48 V System – Integration in GTR EVS

Input for OICA / GTR EVS-Meeting
OICA proposal version 2-2,
May 25th 2015

Modified proposal for GTR EVS

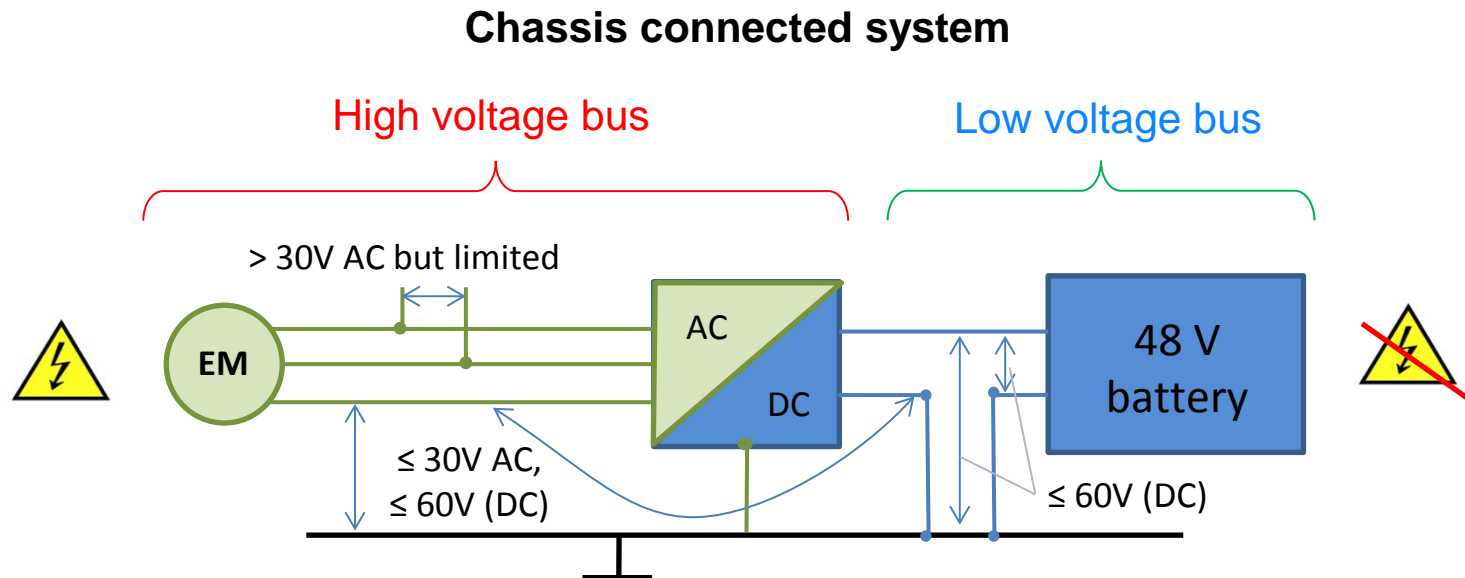
- The proposed text is based on two conditions
 - Electrical circuits, that are galvanically connected to each other, ***are galvanically connected to the electrical chassis***

- the maximum voltage between any live part and the electrical chassis or any exposed conductive part ***does not exceed 30 V AC (rms) or 60 V DC***

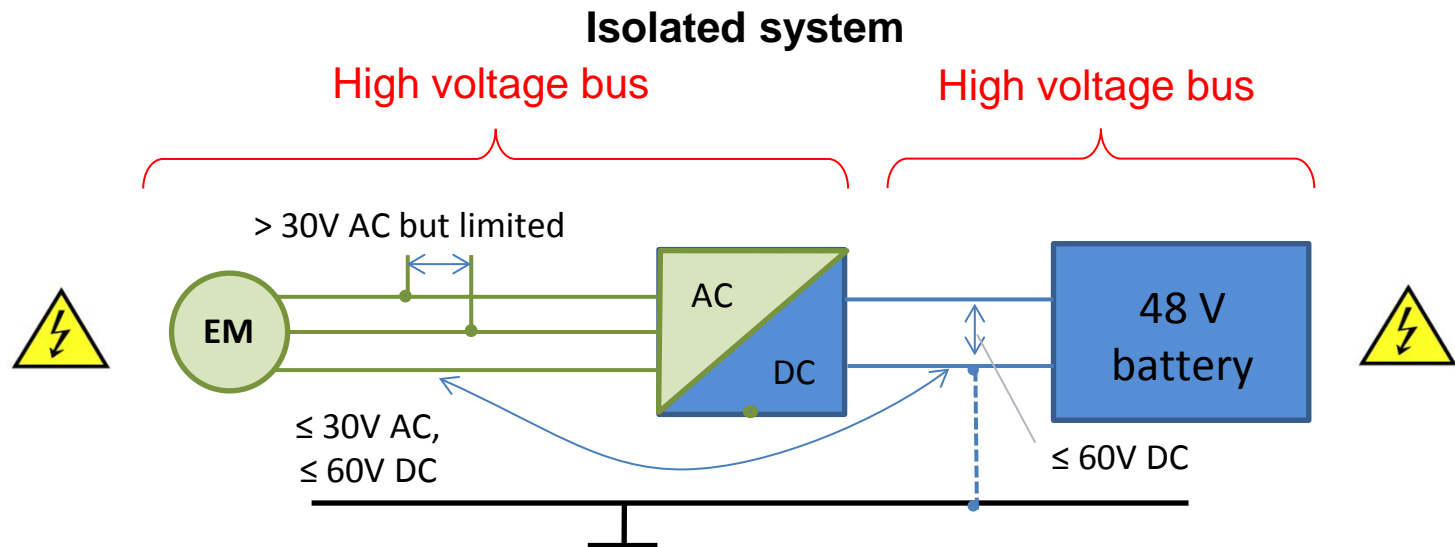
- For **isolated** 48 V systems the whole system needs to fulfill all HV requirements **without any exemption**
 - This applies also when the voltage limits „*maximum voltage between any live part and the electrical chassis or any exposed conductive part does not exceed 30 V AC (rms) or 60 V DC*” are fulfilled, even if a connection of the isolated system to chassis is assumed.

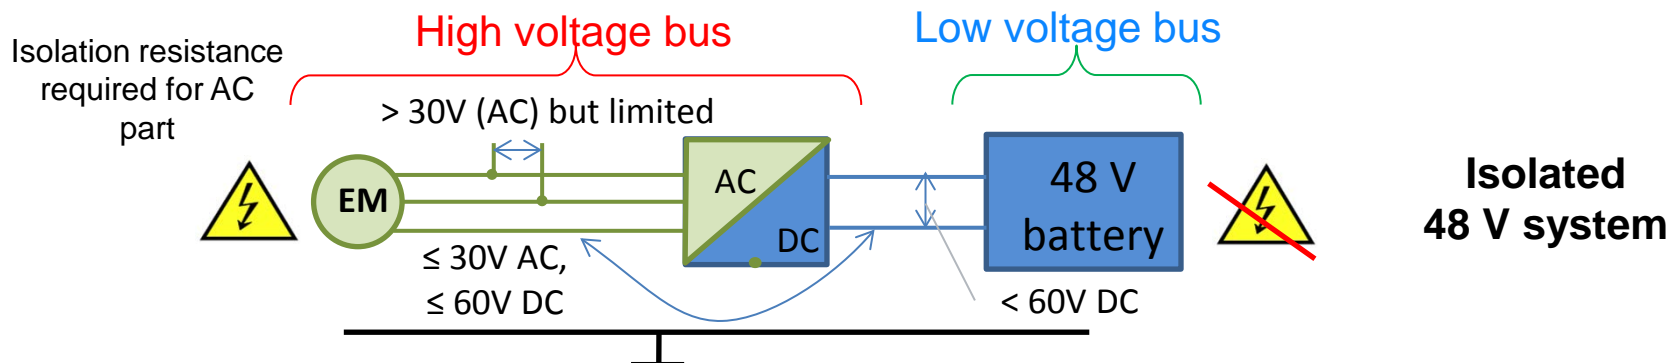
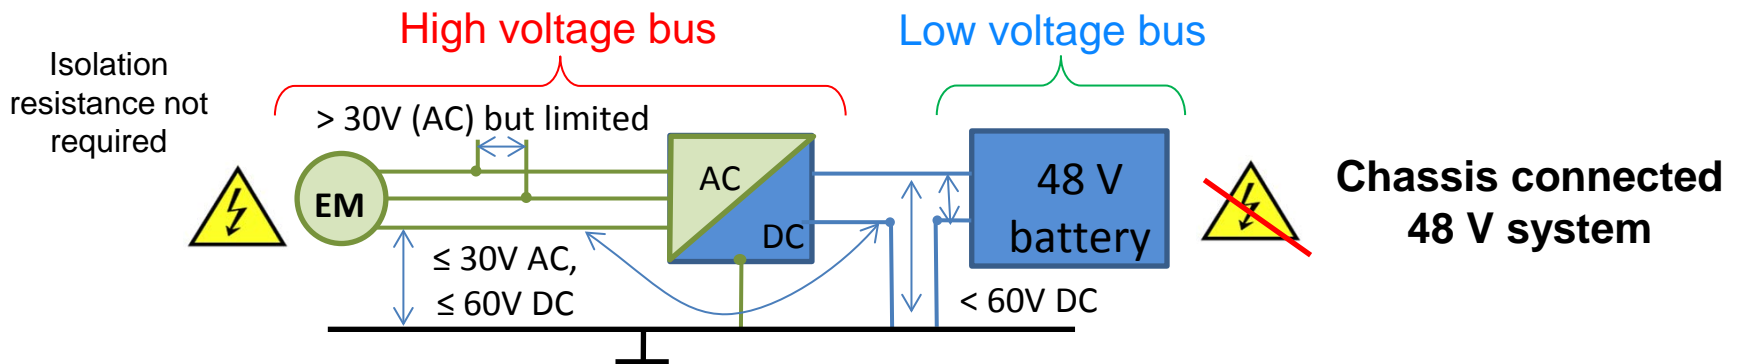
This requirement shall also apply to a REESS which is part of a galvanically connected electrical circuit where the specific voltage condition is not fulfilled, independent of the maximum voltage of the REESS.

Marking required
for 48 V REESS that
is connected to a
circuit does not
comply with the
specific voltages
conditions
specified for 48 V
systems

High voltage electrical circuit – Isolated system with REESS < 60 V DC

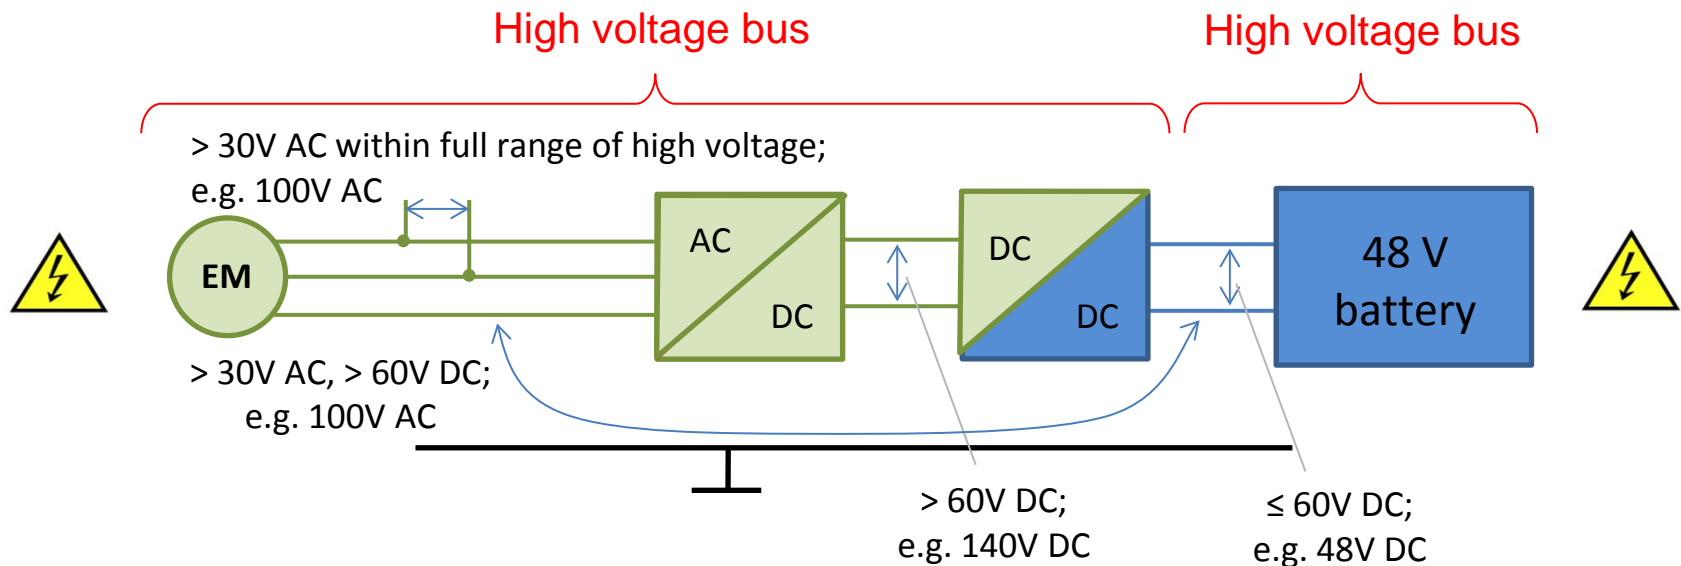
- Systems where the requirement on specific voltage conditions (see „1“ and „3“) are not fulfilled, shall be treated as „high voltage electrical circuit“

Voltages between live part and chassis are given for an assumed condition „connected to chassis“
